Administrative Subdivision Plan No. 620180030, 10202 Falls Road

Administrative Subdivision Plan No. 620180030, 10202 Falls Road: Request to create two lots from one platted lot; located at 10202 Falls Road; 1.14 acres; R-200 zone; 2002 Potomac Subregion Master Plan.

Recommendation – Approval with conditions

Figure 3 - Administrative Subdivision Plan

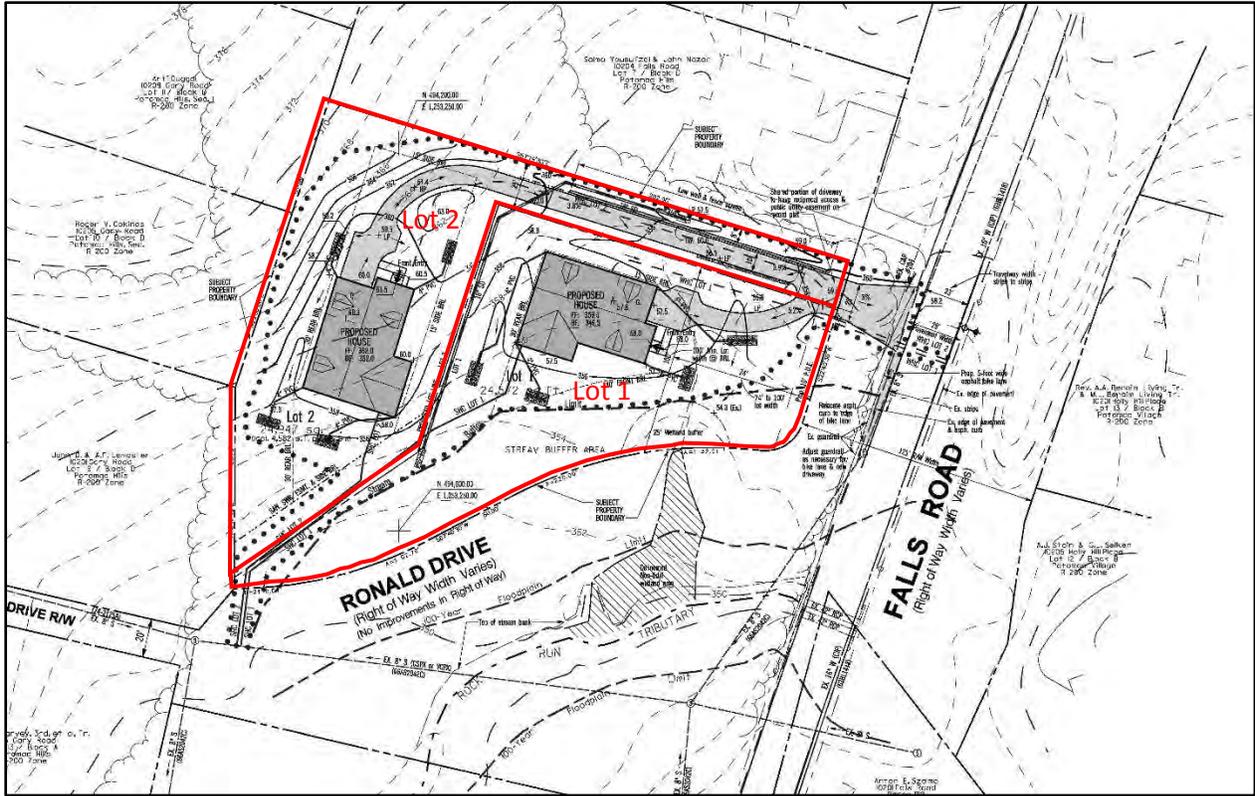
Within the 15-day comment period, Staff received six letters (Attachment 11) from surrounding property owners prompting the Planning Director to refer this Application to the Planning Board in accordance with Section 50.6.3.B.1. These letters primarily focused on environmental issues, lot size/design, and driveway design. Staff has addressed these concerns as follows:

Environmental – The received letters contend that environmental degradation will occur if two lots are created on the Subject Property. While Lot 1, as shown on the Administrative Subdivision Plan, does contain a portion of the 100-foot stream buffer to help protect the stream located in the public right-of-way for Ronald Drive (“paper street”), none of the proposed structures encroach into the stream buffer. The creation of regulatory stream buffers, in this case 100 feet, is the mechanism by which Montgomery County Code protects streams from encroachment and degradation. Montgomery County Code does not place additional setbacks or buffer requirements from regulatory stream buffer lines. As such, the proposed lots and the structures, as shown, meet Planning Board requirements for protection of sensitive environmental features.

Driveway – The received letters state that the driveway is too narrow for cars to pass and doesn’t provide enough parking. It should be noted that driveway design and location is illustrative on all administrative subdivision plans and/or preliminary plans and subject to change at the time of building permit. Secondly, Montgomery County Code places no width requirements on private driveways except when a shared driveway is used as fire access (see approved Fire Access Plan in Attachment 10). In which case, a driveway must be at least 20 feet in width up to the last shared point of the driveway. The last shared driveway point in this Application occurs where the driveway for Lot 1 splits off near the front property line. The rest of the driveway for Lots 2 is not governed by any specific width requirements due to the extremely low volumes on a single driveway. Furthermore, the MCDPS will provide the permit review and inspection of any driveway construction at the time of building permit.

Figure 4 – Variance Trees and Site Constraints

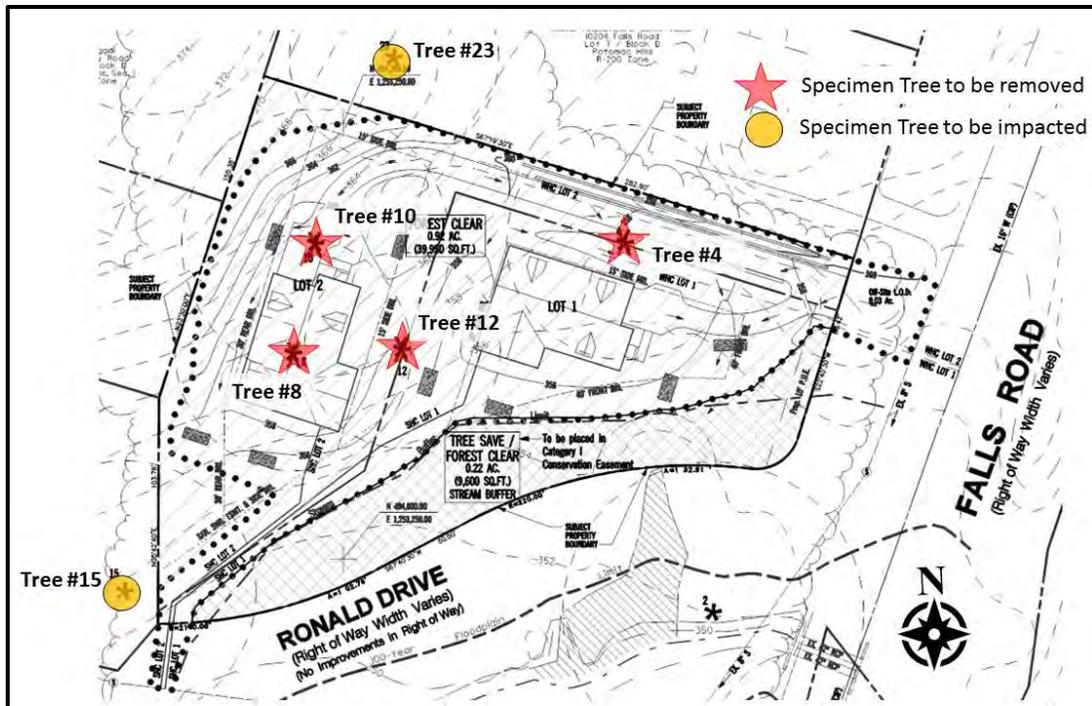
Per Section 22A-21(a), an applicant may request a variance from Chapter 22A if the applicant can demonstrate that enforcement of Chapter 22A would result in an unwarranted hardship. In this case, the Applicant is faced with having to remove 4 specimen trees and impact 2 others. 4 of these trees are located on the site and 2 are located off-site on adjoining properties (Figure 4).

Trees #4, #8, #10 and #12 are proposed to be removed. These four trees are located within the active construction area of the residential structures for this subdivision. There is little preventative actions that can be taken to ensure the health of these trees either during or after construction. Trees #15 and #23 are on adjoining properties outside of the limits of disturbance (LOD), but will have their critical root zones (CRZ) impacted with either site grading or the installation of the sewer lines for the proposed homes. Trees #15 and #23 will have approximately 23% and 12% of their critical root zones (CRZ), respectively, impacted with this construction activity. The arboriculture industry standard for construction impacts to trees is to limit those impacts to no more than approximately 30 percent of the Critical Root Zone (CRZ). More than 30 percent impact to the CRZ and the overall healthy viability of the tree comes into question. Therefore, Staff believes that Trees #15 and #23 will recover from these impacts.

M-NCPPC Staff has determined that the impacts to these trees for the construction on these lots are unavoidable. The site is very constrained with almost no excess room to relocate the residential structures to avoid impacts to the specimen trees. The location of the proposed homes has been pushed as far away as possible from the southern property line to lessen the impacts to the stream and stream buffer area.

Administrative Subdivision Plan
10202 FALLS ROAD
Lot 8, Block D, Potomac Hills
ELECTION DISTRICT #10
MONTGOMERY COUNTY, MARYLAND

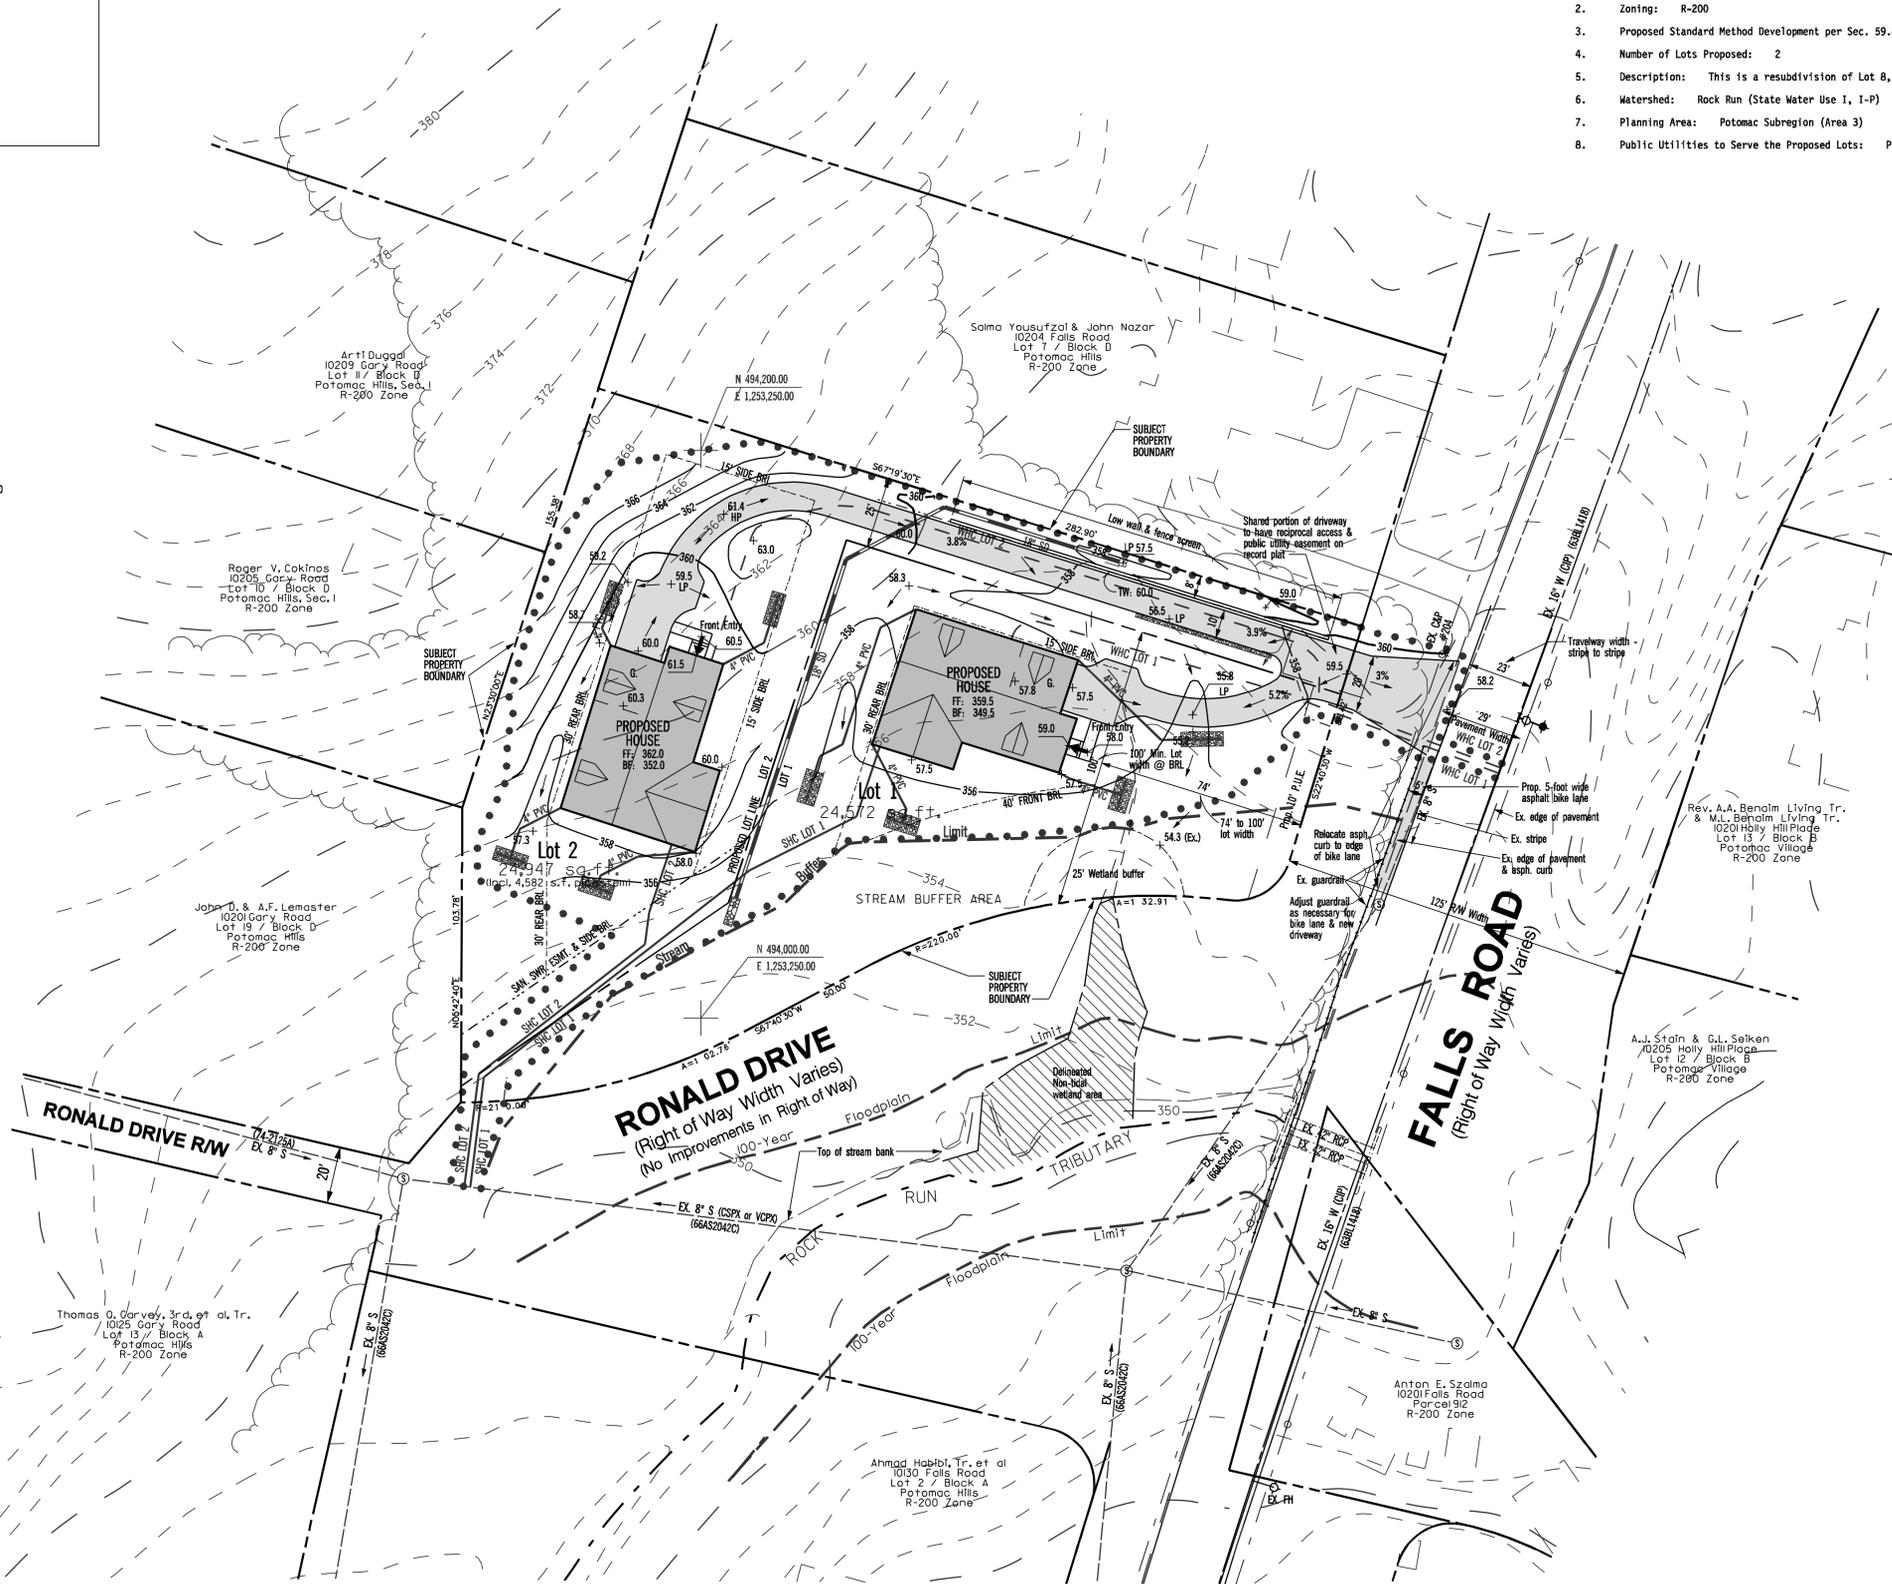
I object to the proposal to squeeze two houses into this area on Falls Road. The drawing of the proposed development raises several issues.

One serious issue is that the drawing shows the house closest to Falls Road with the proposed driveway on top of a stream buffer area in two places. This is not appropriate.
